eceiveu by OCD. 1/24/202	+ 12.40.32 1 M			I uge I of	
	UNITED STAT DEPARTMENT OF THE UREAU OF LAND MAN	E 5. Lease Serial No.	FORM APPROVED OMB No. 1004-0137 Expires: October 31, 2021 5. Lease Serial No.		
Do not use th	Y NOTICES AND REP his form for proposals ell. Use Form 3160-3 (A	6. If Indian, Allottee	6. If Indian, Allottee or Tribe Name		
	TIN TRIPLICATE - Other inst	ructions on page 2	7. If Unit of CA/Ag	reement, Name and/or No.

Update casing and cement program to current design.

Revised Permit Information 11/08/2023:

Well Name: Audacious 19 Fed Com 221H

Design A

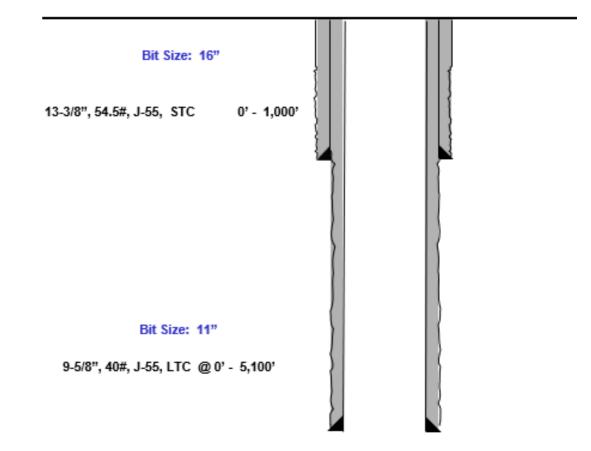
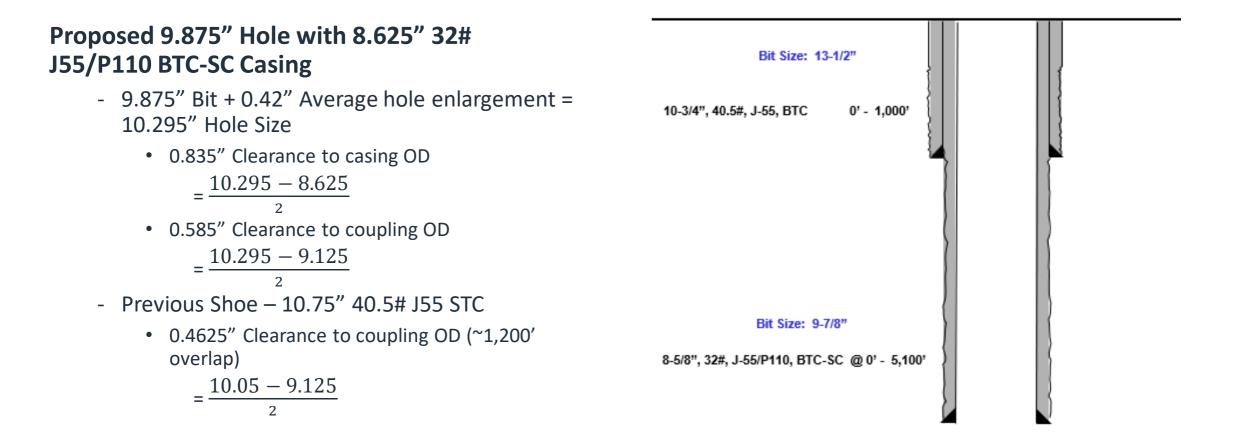
EOG requests permission to allow deviation from the 0.422" annulus clearance requirement for the intermediate (salt) section from Onshore Order #2 under the following conditions:

- 11" Bit + 0.52" Average hole enlargement = 11.52" Hole Size
 - 0.9475" Clearance to casing OD

• 0.4475" Clearance to coupling OD
